ANDREWS MECHANICAL, INC.

Written Comments Regarding Proposal WAC 51-56-0800 807.3 Air gap removal option in exceptions. Please remove this exception as it would be bad for our citizens. See reasons below and drawings page 3.

FIGURE 807.4A
DISHWASHER AIRGAP CONNECTION THROUGH DISPOSAL

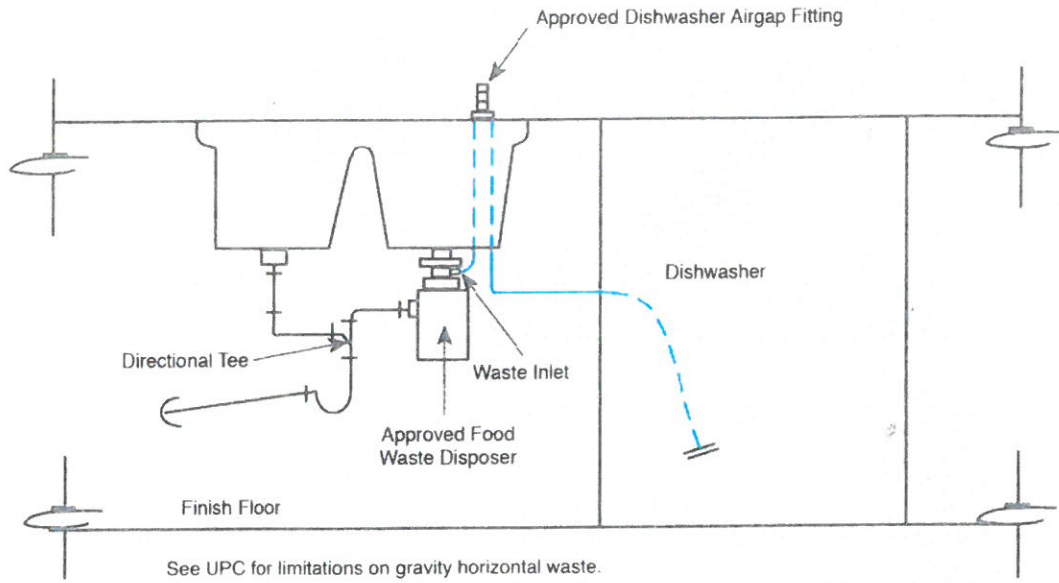
4) Note in Figure 807.4A, the air gap is above the rim of the sink so there is no way the plugged sink slime or bacteria can get into the dishwasher. See, in figure 807.4B, how the air gap is designed with an air gap. Drawings from IAMPO Training Manual.
